MAINE TURNPIKE AUTHORITY

ADDENDUM NO. 1

CONTRACT 2018.08

Bridge Repairs
Dennett Road Overpass Mile 0.6
Snow Fence Installation
Wilson Road Underpass Mile 2.0
Wearing Surface Repairs
York River Bridge Mile 5.2

SHEET NUMBER: MT-09
 Addendum 1 (Page 9 of 36) 12 OF 40

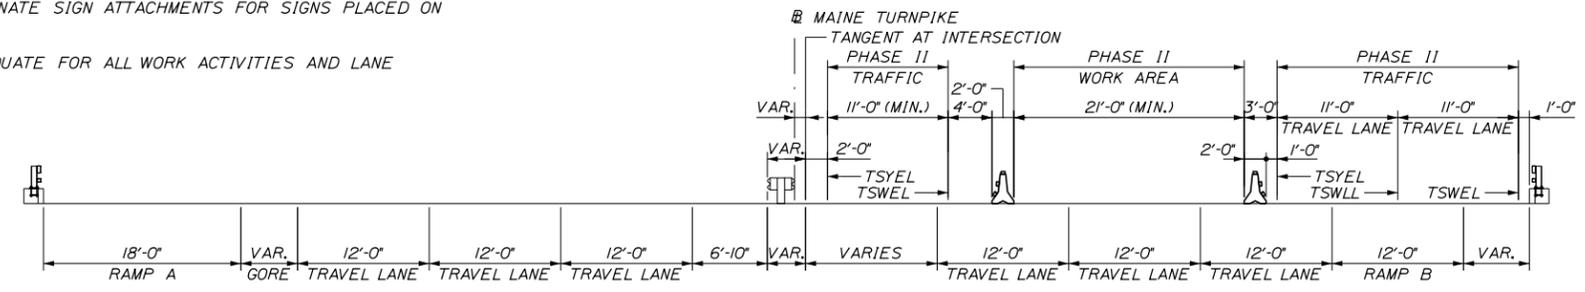
Plan Sheet 12 of 40, "Maintenance of Traffic Phase II" is deleted and replaced in its entirety with the attached revised sheet 12.

| 1 | Deleted barrier marker note | JRH | 2/9/18 |

SHEET NUMBER: GP-01
 Addendum 1 (Page 12 of 36) 17 OF 40

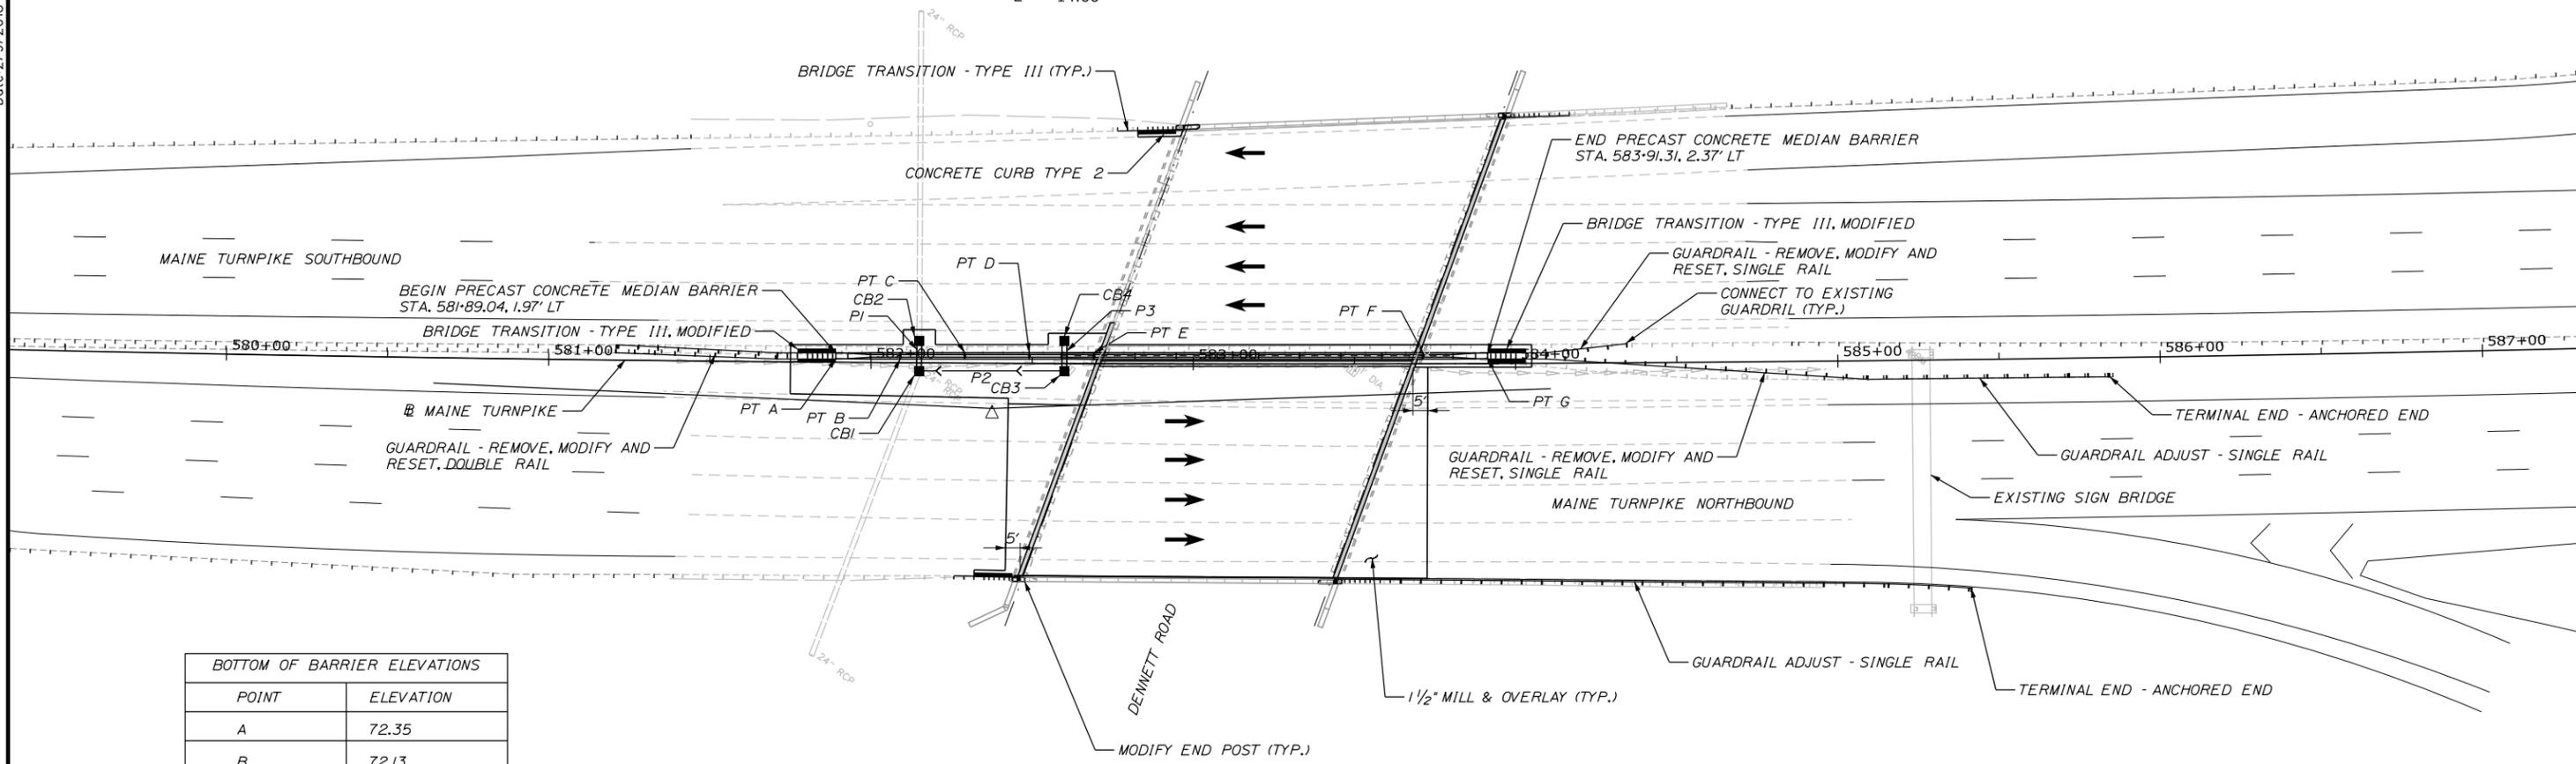
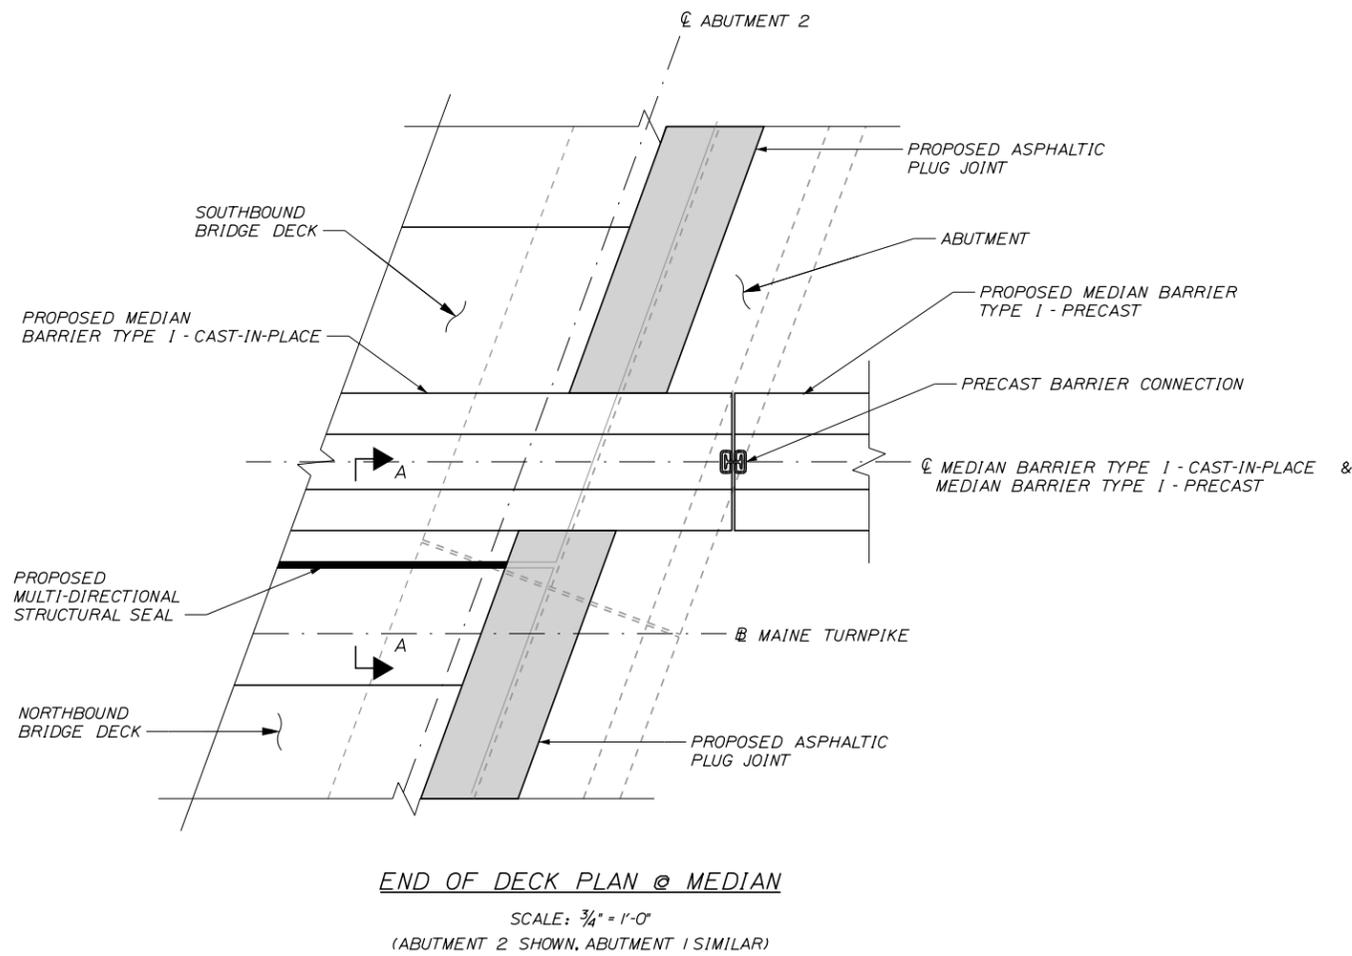
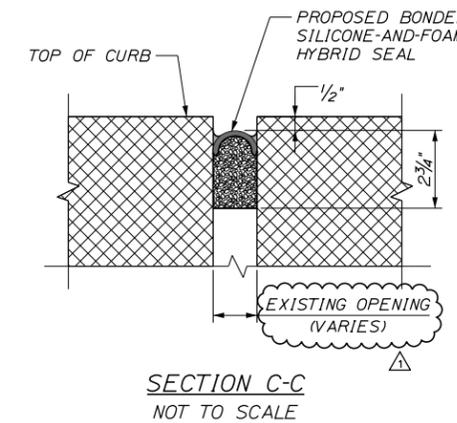
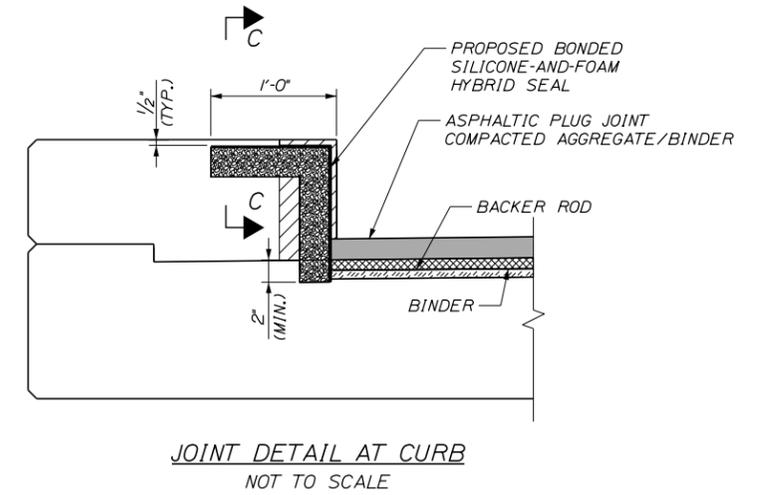
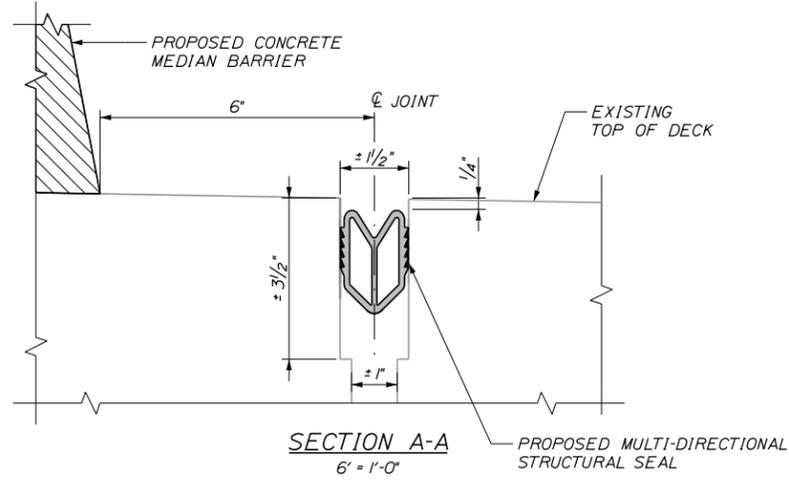
Plan Sheet 17 of 40, "General Plan" is deleted and replaced in its entirety with the attached revised sheet 17.

| No. | Revision | By | Date |
|-----|------------|-----|--------|
| 1 | Added Note | JRH | 2/9/18 |
